# Summary of Comments on P:\100\100.067\constr\street \100.067-COVER-street-STM C0.1 (1)

Page: 3

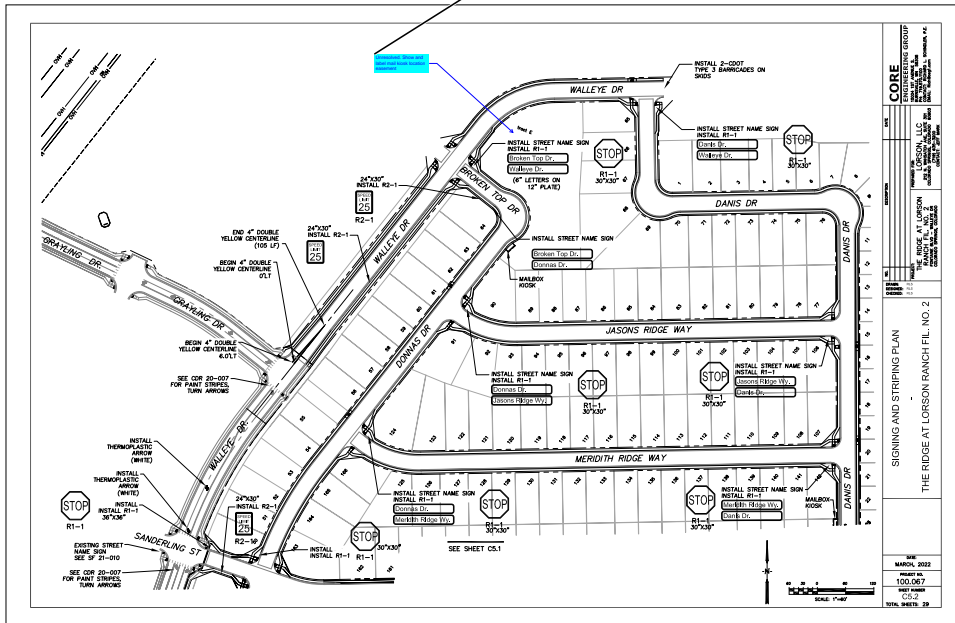
Author: CDurham Subject: Callout Date: 5/3/2022 1:29:07 PM

According to comment responses, Walleye was downgraded to a local street. Please revise and update posted and design speeds.

Author: RSchindler Subject: Sticky Note Date: 6/3/2022 7:31:12 AM  
ADDED STATIONING TO TYPICAL.

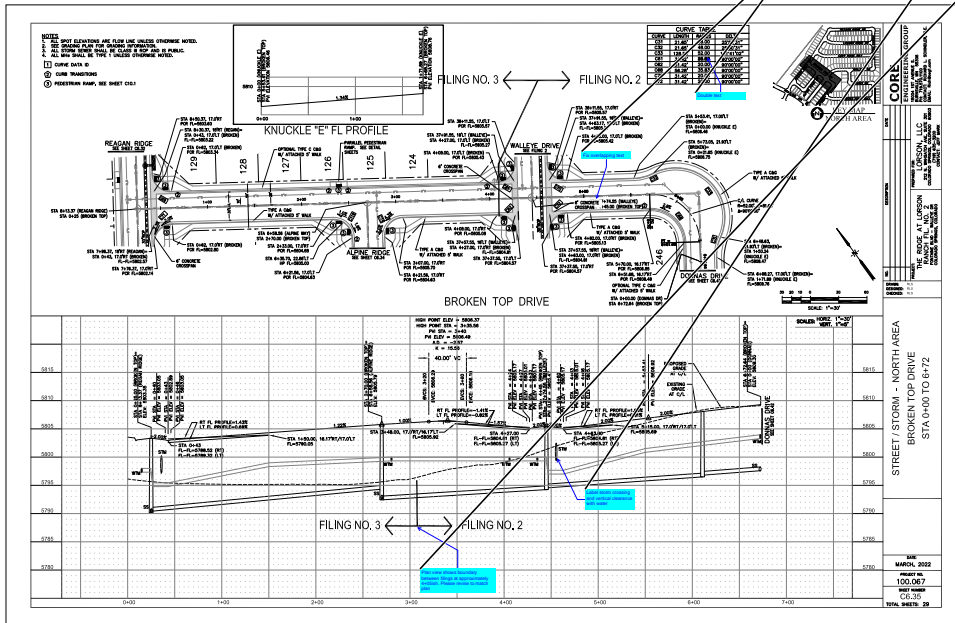
- Author: lpackman Subject: Text Box Date: 6/3/2022 8:53:22 AM  
Unresolved. Show all lot numbers.

- Author: lpackman Subject: Text Box Date: 5/3/2022 8:54:00 AM  
Unresolved. Lengths & inverts do not match FDR

- Author: lpackman Subject: Callout Date: 5/3/2022 8:54:18 AM  
Unresolved. Inverts do not match FDR

- Author: RSchindler Subject: Sticky Note Date: 6/3/2022 8:24:28 AM  
NUMBERS ADDED

- Author: RSchindler Subject: Sticky Note Date: 6/3/2022 8:25:40 AM  
MODEL UPDATED

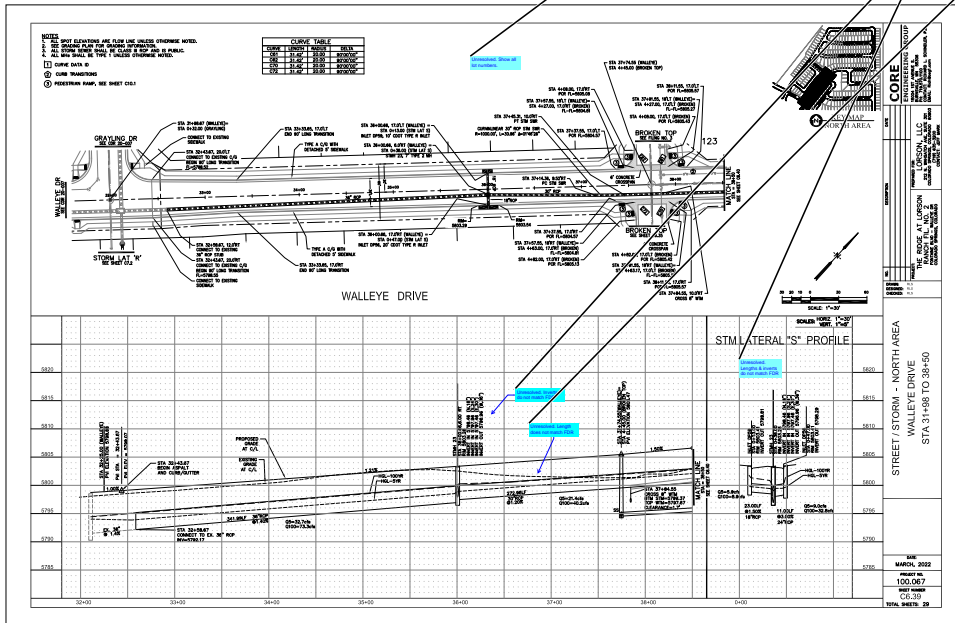
- Author: lpackman Subject: Callout Date: 5/3/2022 8:54:29 AM  
Unresolved. Length does not match FDR

- Author: lpackman Subject: Text Box Date: 5/3/2022 8:56:10 AM  
Unresolved. Lengths, slopes & inverts do not match FDR
- Author: RSchindler Subject: Sticky Note Date: 6/3/2022 8:26:08 AM  
MODEL UPDATED
- Author: lpackman Subject: Text Box Date: 5/3/2022 8:55:49 AM  
Unresolved. Lengths, slopes & inverts do not match FDR
- Author: RSchindler Subject: Sticky Note Date: 6/3/2022 8:25:50 AM  
MODEL UPDATED

- Author: RSchindler Subject: Sticky Note Date: 6/3/2022 8:24:35 AM  
MODEL UPDATED

- Author: RSchindler Subject: Sticky Note Date: 6/3/2022 8:24:42 AM  
MODEL UPDATED

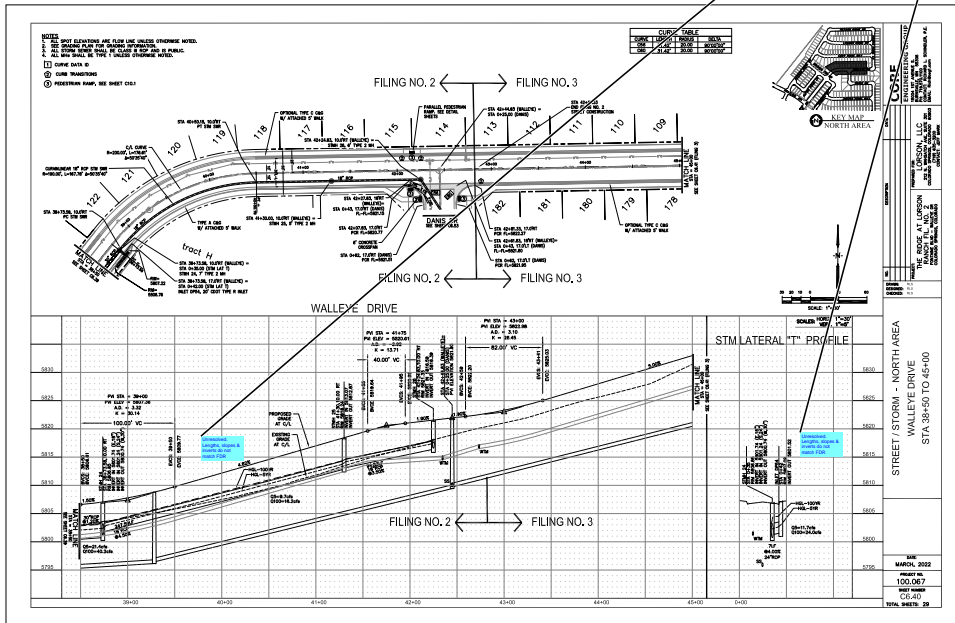
- Author: Ipackman Subject: Text Box Date: 5/3/2022 8:56:42 AM  
 Unresolved. Show and clearly identify boundary between Filing 2 and 3
- Author: RSchindler Subject: Sticky Note Date: 6/3/2022 8:30:55 AM  
 SHEET 6.35 HAS THAT LABEL
- Author: CDurham Subject: Callout Date: 5/5/2022 2:57:31 PM  
 Revise ROW lines so sidewalk is located within it.
- Author: RSchindler Subject: Sticky Note Date: 6/3/2022 8:36:48 AM  
 ROW updated
- Author: Ipackman Subject: Callout Date: 5/3/2022 8:57:08 AM  
 Unresolved. Label storm crossing and vertical clearance with water
- Author: RSchindler Subject: Sticky Note Date: 6/3/2022 8:37:46 AM  
 labeled

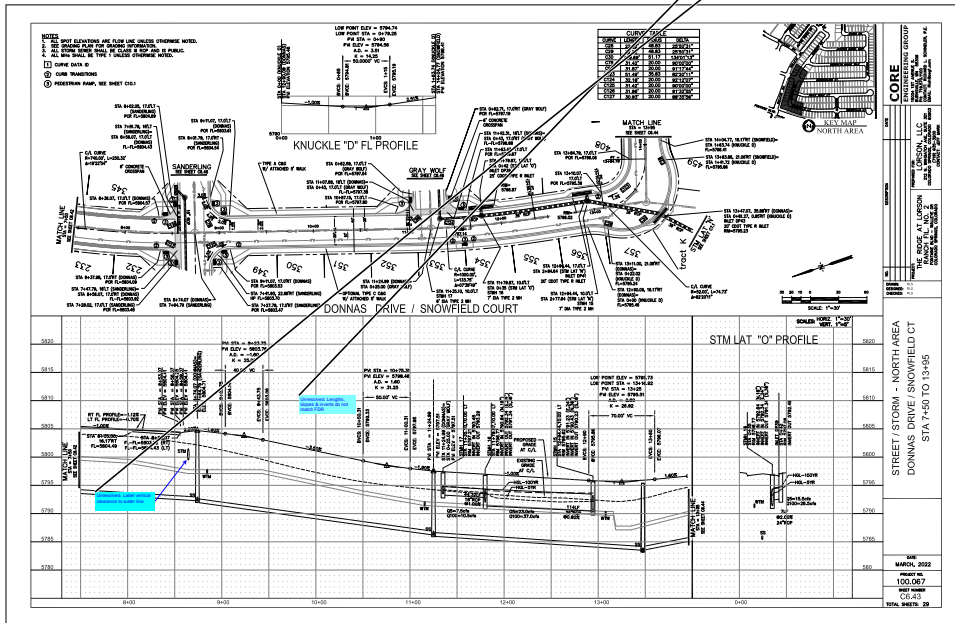
Author: Ipackman Subject: Text Box Date: 5/3/2022 8:58:21 AM

Unresolved. Lengths, slopes & inverts do not match FDR

Author: RSchindler Subject: Sticky Note Date: 6/3/2022 8:40:24 AM  
model updated

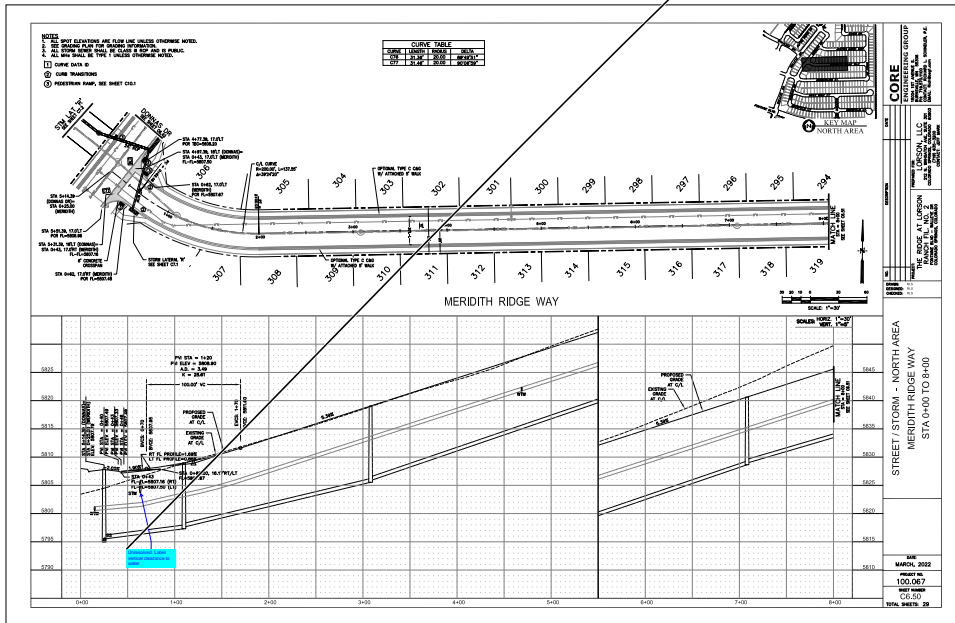
Author: Ipackman Subject: Callout Date: 5/3/2022 8:57:58 AM

Unresolved. Label vertical clearance to water line

Unresolved. Need to show how proposed grading ties into existing ground

Author: RSchindler Subject: Sticky Note Date: 6/3/2022 8:40:17 AM  
labeled

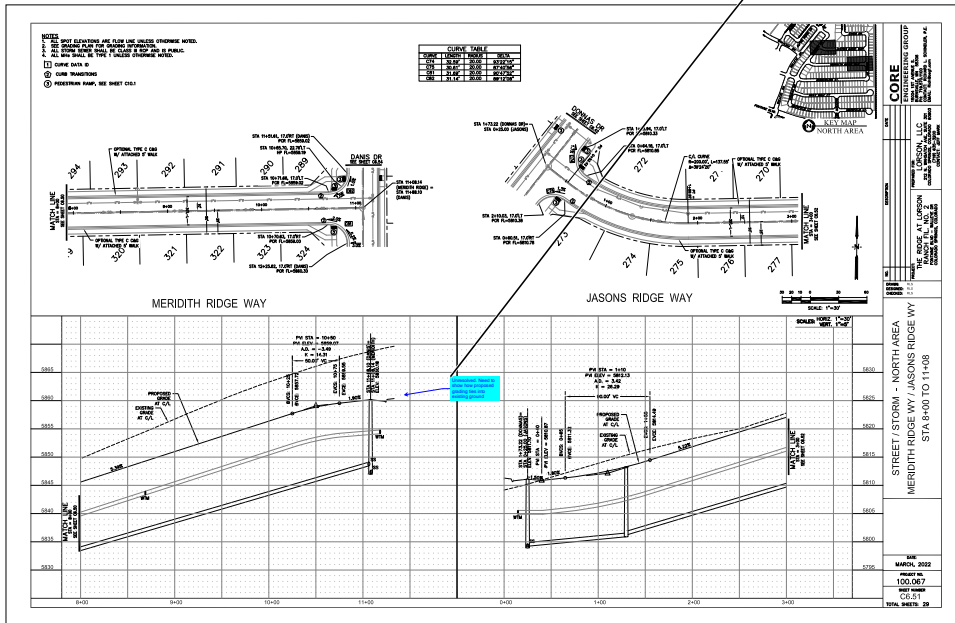
Author: lpackman Subject: Callout Date: 5/3/2022 10:05:47 AM  
Unresolved. Rim elevation appears low

Author: lpackman Subject: Callout Date: 5/3/2022 10:05:27 AM  
Unresolved. Storm inv's, pipe length & slope do not match FDR

Author: RSchindler Subject: Sticky Note Date: 6/3/2022 8:48:30 AM  
grading extends beyond profile.

Author: RSchindler Subject: Sticky Note Date: 6/3/2022 8:52:03 AM  
rim is correct. its just how it's shown in the profile and the street grade.

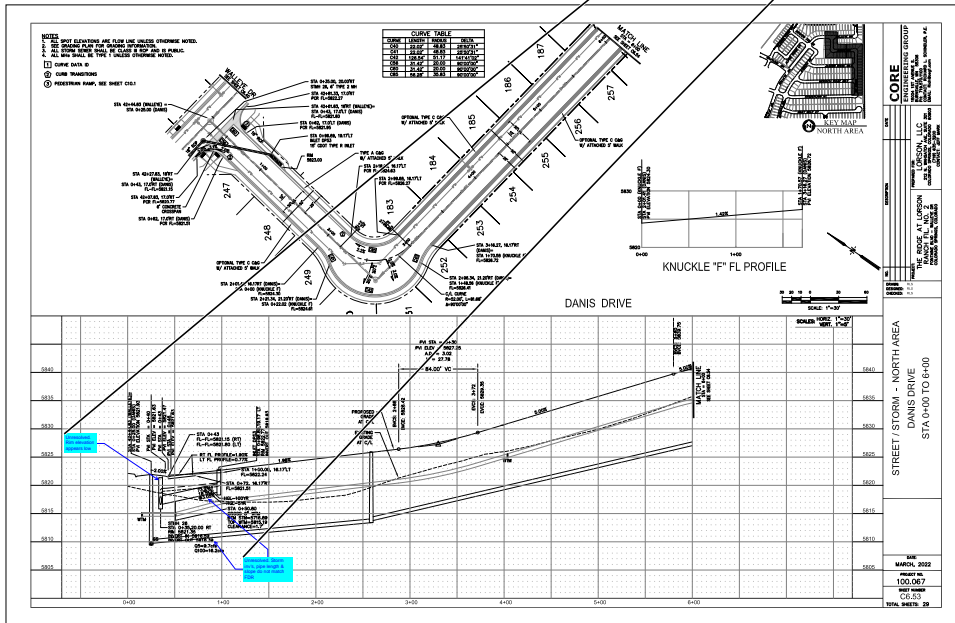
Unresolved. Need to show how proposed grading ties into existing ground

Author: RSchindler Subject: Sticky Note Date: 6/3/2022 8:52:10 AM  
model updated
